Product Change Notification

KT11 range

PCN 09-07 – KT11

C&K components

Fig.1 View of KT construction

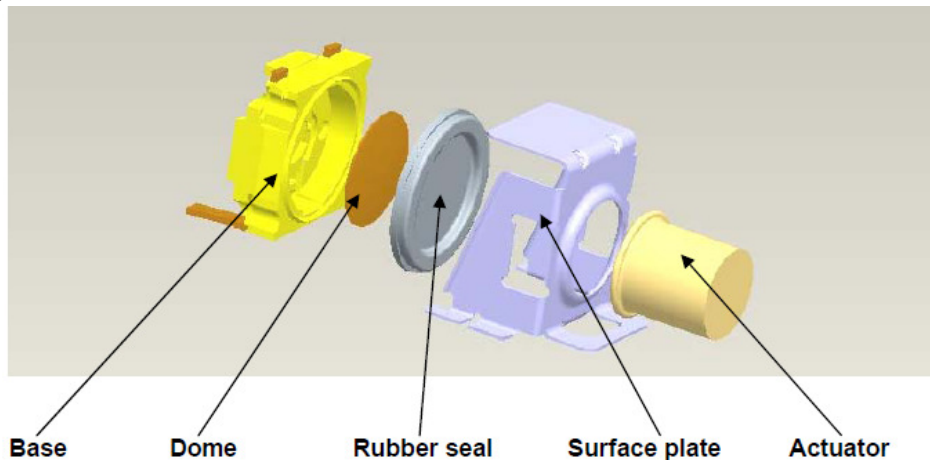
a) To shorten the lead time of the Base component, a new injection mold will be launched locally in China.

- New injection mold for Base to be launched.
- Color of Seal to be changed from black to white (without material changing).
- Other features, characteristics, specification, manufacturing footprint remain unchanged.

Fig.2 View with new Seal and current Seal

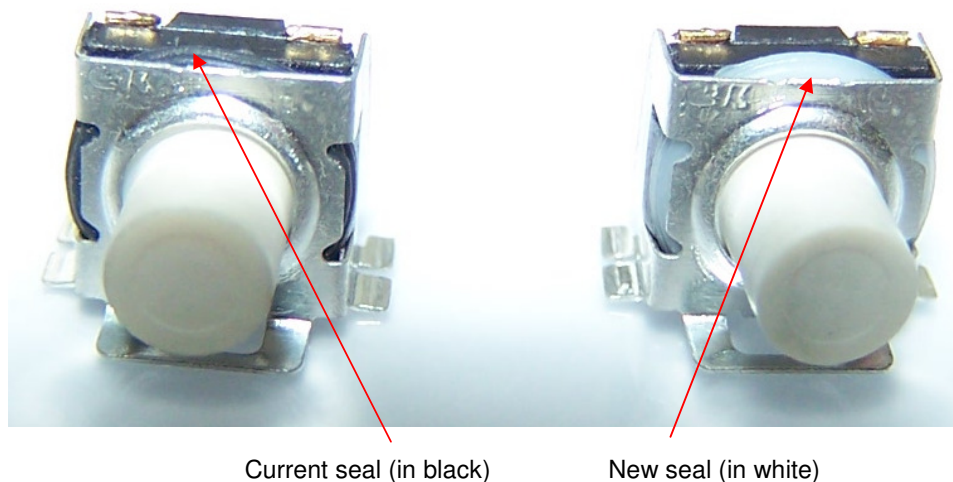
b) To improve the inspection in process, color of the seal to be changed from black to white.
